**DRAFT - 3/16/2000
Summary of the Proposed Central Delta Intakes Analysis**

Description of the Proposed Central Delta Intake Options and Components

Figure 1 - Central Delta Intakes Options and Components (as Presented)

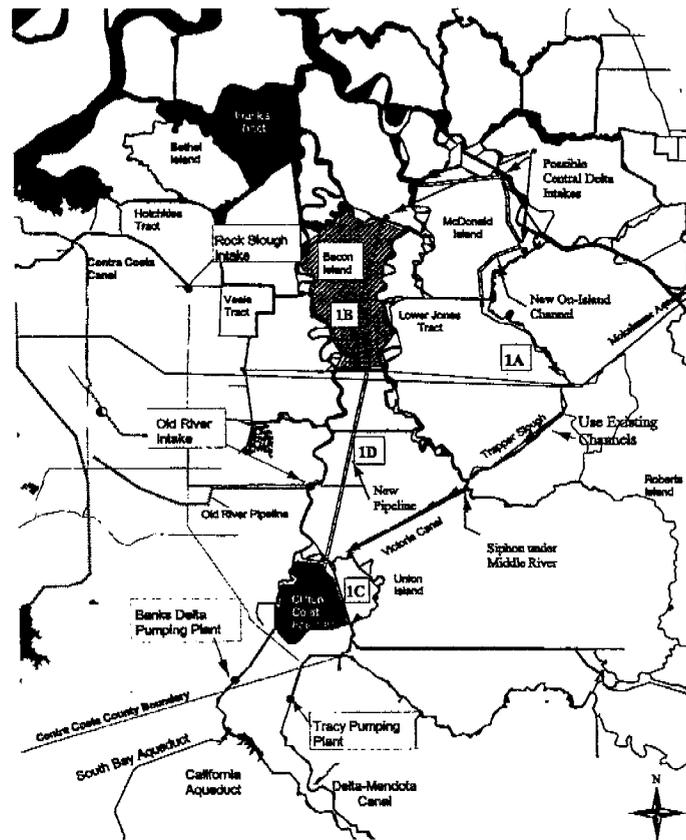
The McDonald Island Intake will be very difficult to implement as presently outlined in the proposal. Some elements of this portion of the proposal however are being looked into. The South Delta Improvements Program has expanded the scope and analysis of various project components to include combinations of various barrier configurations, dredging alternatives, consolidation of agricultural diversions, and on-island water distribution systems that may serve a portion of South Delta needs (for example, the on-island distribution system being considered in the SDIP could pump water from Clifton Court Forebay and serve a portion of the areas most affected by not placing a Grantline barrier).

The SDIP has not considered a no-barrier alternative that distributes water to all South Delta lands via an extensive on-island distribution system as presented in the Central Delta Intake alternative (the McDonald Island Intake side of the alternative). An extensive on-island distribution system that would divert from an isolated diversion channel (i.e. screened), would have to serve approximately 100,000 acres distributed over several Delta islands. A number of issues make implementation of this component difficult as a Stage 1A action including:

- extensive timeline to stage and construct this system;
- water rights issues;
- high costs (up to \$500 million); and,
- cooperation of landowners to implement this system

Therefore, since there are functionally a number of alternatives that will improve South Delta water quality and diversion issues, this component of the proposed alternative does not solve the problems in the South Delta.

A proposed future phase of the McDonald Island diversion included a connection to the SWP/CVP export facilities. It was determined that having only one connection to the Central Delta would be functionally equivalent to two since both intakes would be from the Central Delta. Therefore, a connection from a storage island would serve this purpose better. Consolidating two intake channels into one further questions the need to serve the South Delta needs from the Central Delta diversion.
